ILLINOIS ENVIRONMENTAL PROTECTION AGENCY WATER POLLUTION CONTROL PERMIT

SUBJECT: ARNOLD ENGINEERING CORPORATION (MARENGO FACILITY) - Wastewater Treatment and Recycle

Denial of State Permit Application

Wastewater Permit Denial Arnold Magnetic Technologies Marengo, Illinois

Attachment 2 Weaver Groundwater Contour Maps

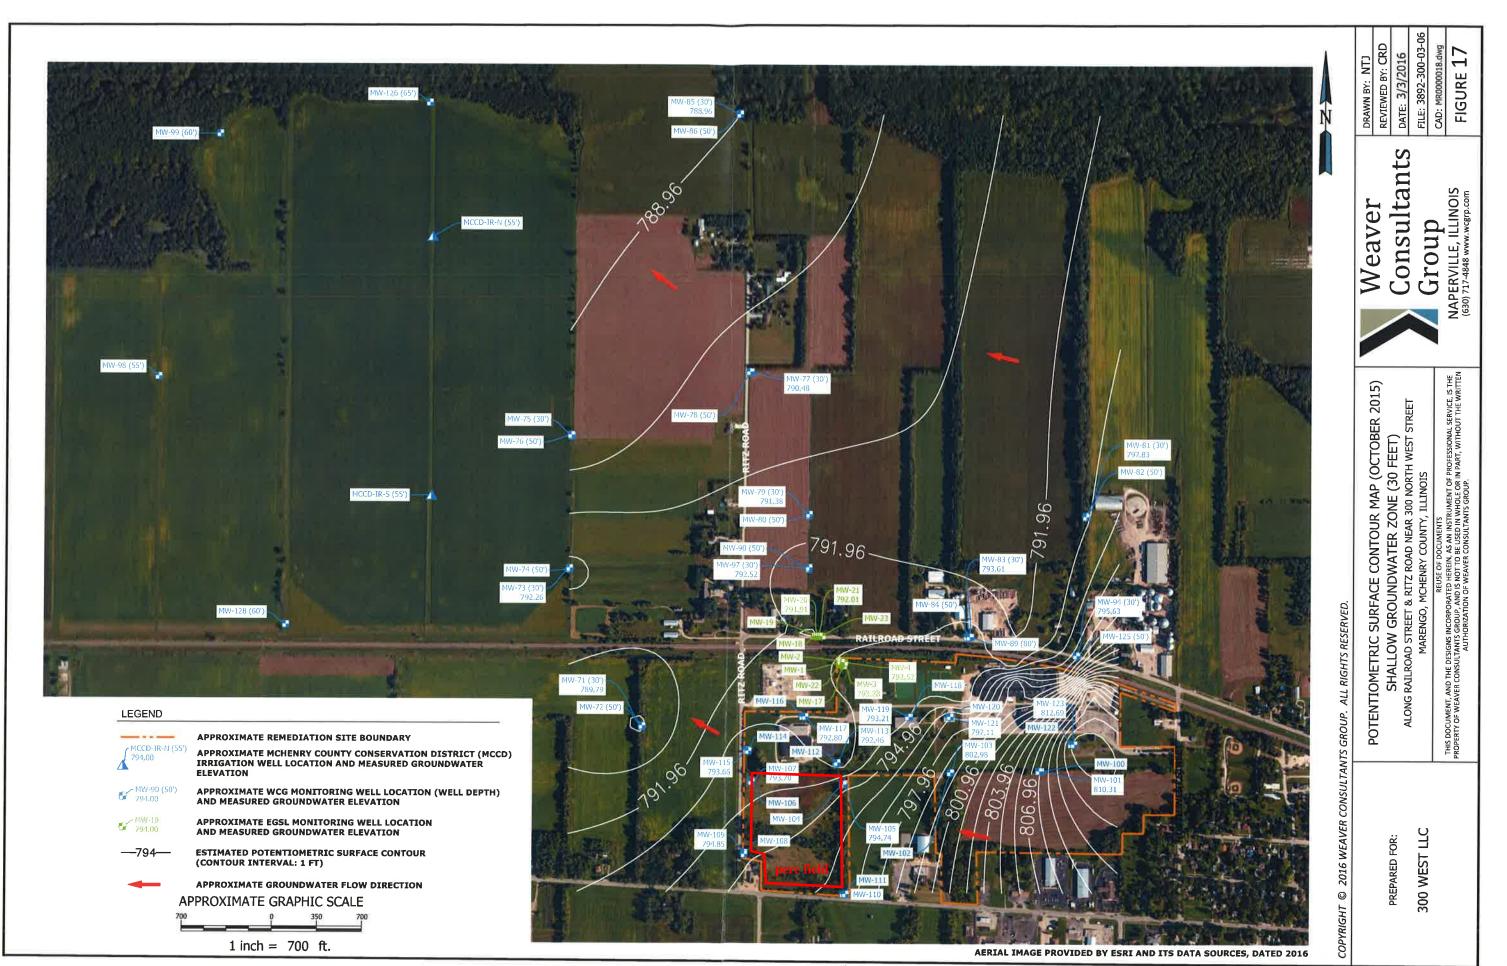
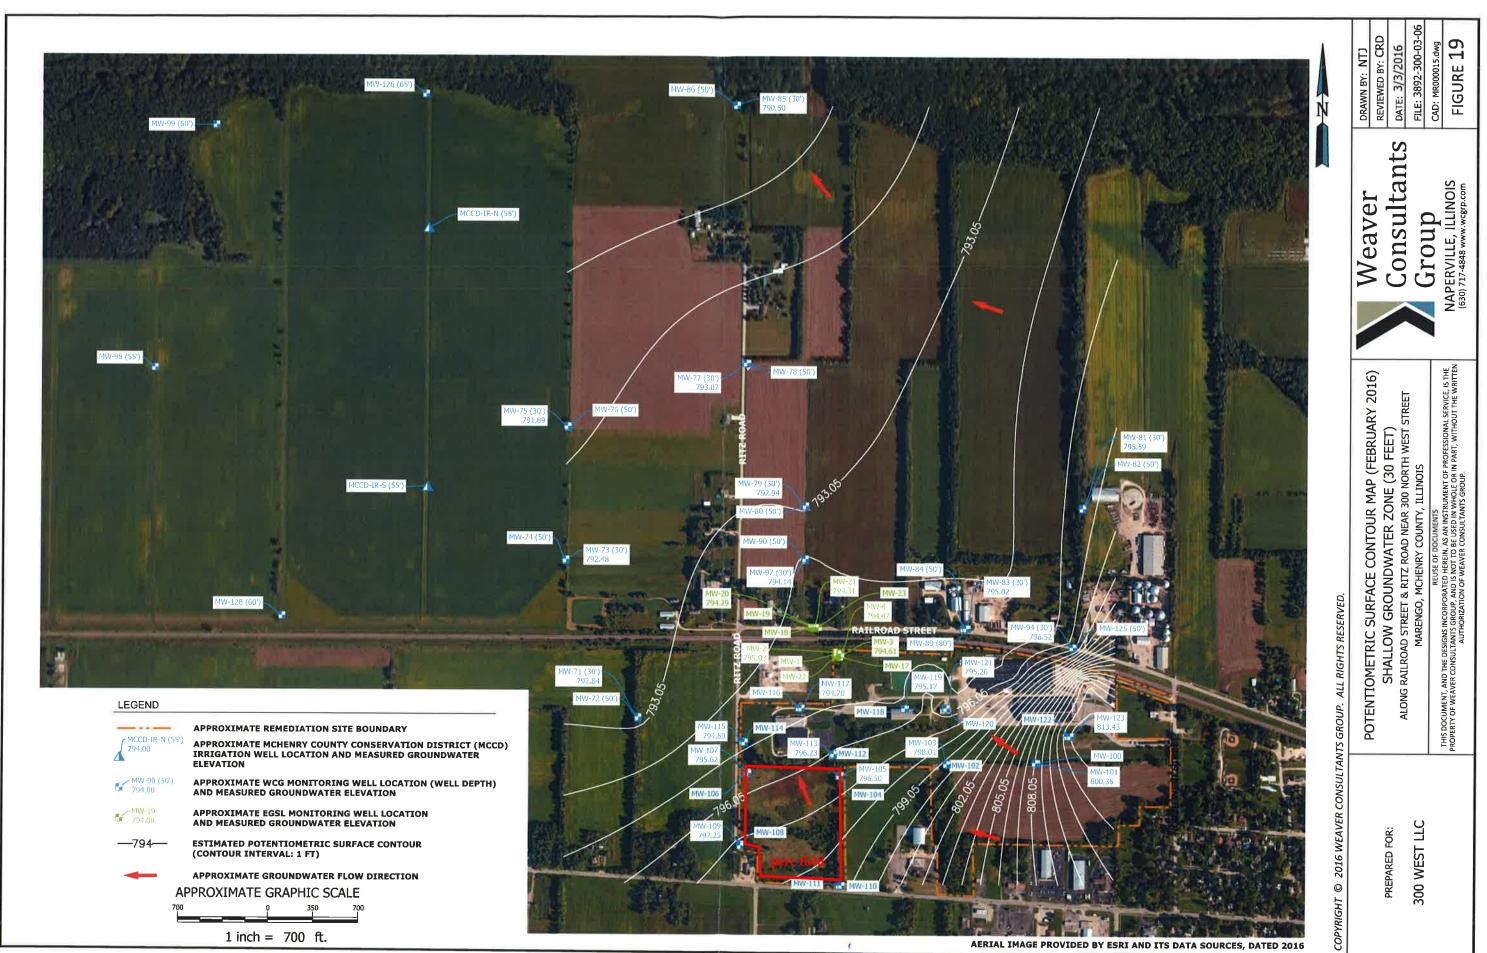
Historic groundwater monitoring indicates exceedances for VOC's and some metals in the groundwater near the ponds. The application must address this groundwater contamination, and demonstrate that operation of the ponds has not and will not contribute to violations of the groundwater quality standards as found at 35 Ill. Adm. Code Part 620.

With respect to the Agency's question regarding whether the wastewater pond system and percolation field are exacerbating movement of existing contamination at the Site, water percolating at ground surface (a recharge area) can potentially alter groundwater flow, and could consequently affect the movement of existing groundwater contamination by locally altering groundwater flow gradients. The mechanism by which this could occur includes:

In conclusion, the analytical and hydraulic information AECOM reviewed indicates the wastewater pond system is not a material contributor of chlorinated solvents or metals to shallow groundwater, nor is the water treatment system the likely source of contamination at the Site. Indeed, historical laboratory data for pond system water used as the basis for previous permitting show either non-detections or low concentrations for the specific constituents of potential concern in shallow groundwater at the Site.
